RECEIPT DATE: 10/27/20 **ONSITE SEWAGE DISPOSAL SYSTEM** P 572834

ON-SITE SEWAGE DISPOSAL SYSTEM PLAN

RE: F-16-088, Percival Property

**Re: Percival Property, Lot 2, 14529 Ambreen Way
Onsite Sewage Disposal System
Revised Submission**

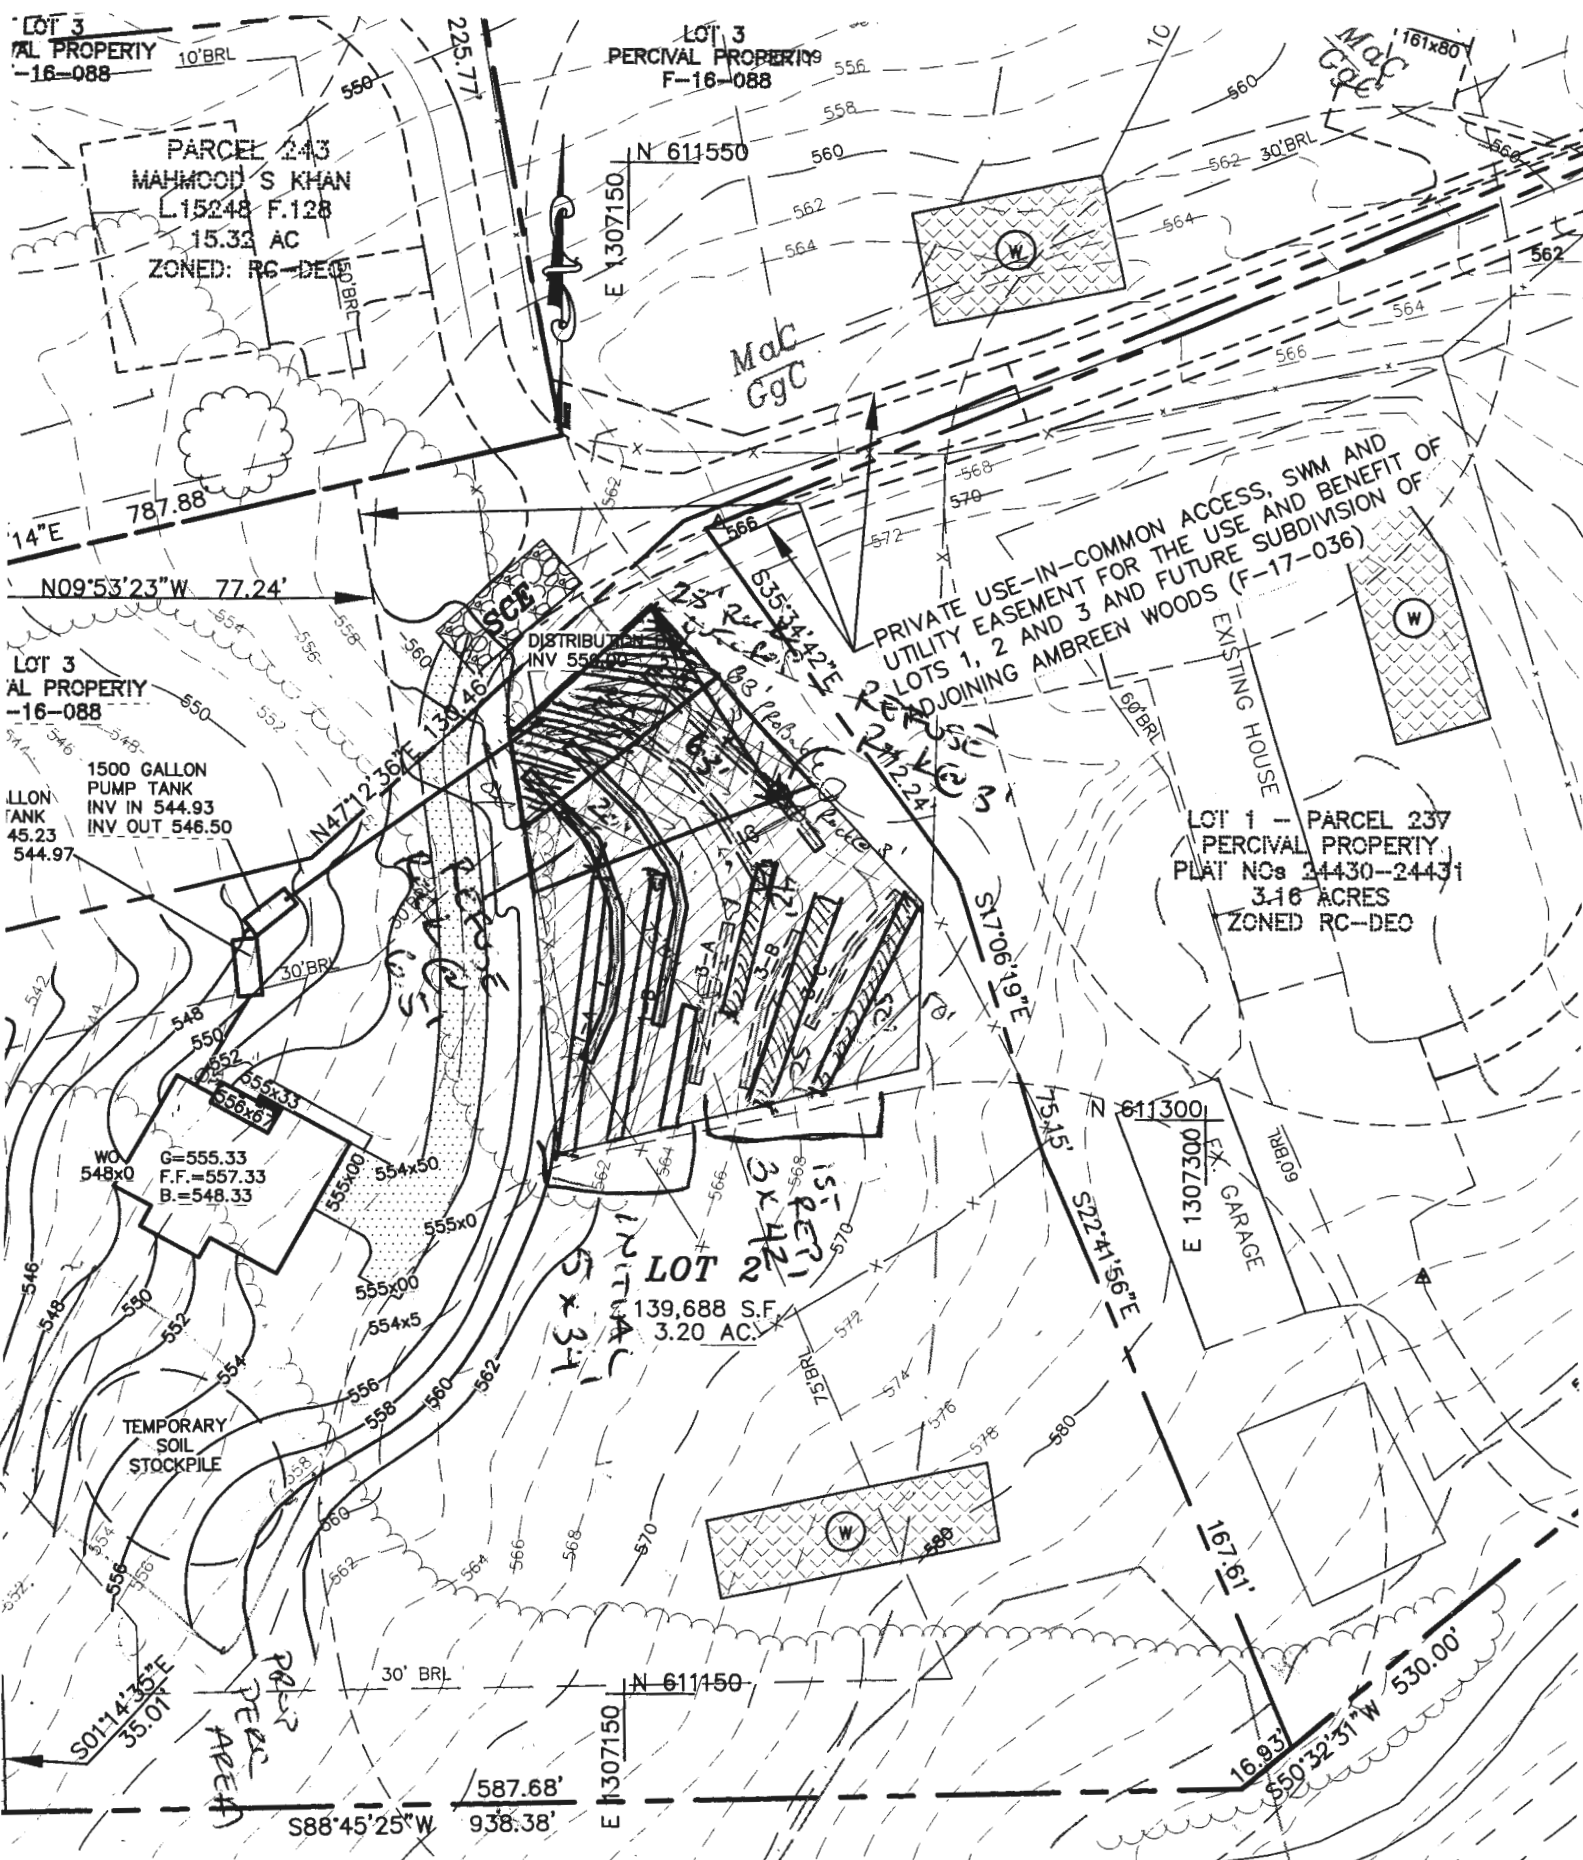
1. *The pump tank is too deep and needs to be moved to get less than 3 feet of cover.*

2. *The pump tank is too small and needs 600 gallons of emergency storage above the high-water alarm.*

3. *Please verify if this is pump to gravity trenches.*

4. *Need to show point on pump curve where the design head and flow rate meet.*

Contours were adjusted to reduce the cover over the pump tank. Notes 6, 7 were revised.

The system design was revised to include a 1,500-gallon pump tank. The storage above the high-water alarm is now 675 gallons, which is greater than the daily 600 gallons.

The system is designed to pump flow to a distribution box which feeds the trenches via gravity. A note to this effect has been added to the General Notes.

The design head and flow rate intersection with the pump curve is shown on the plan.
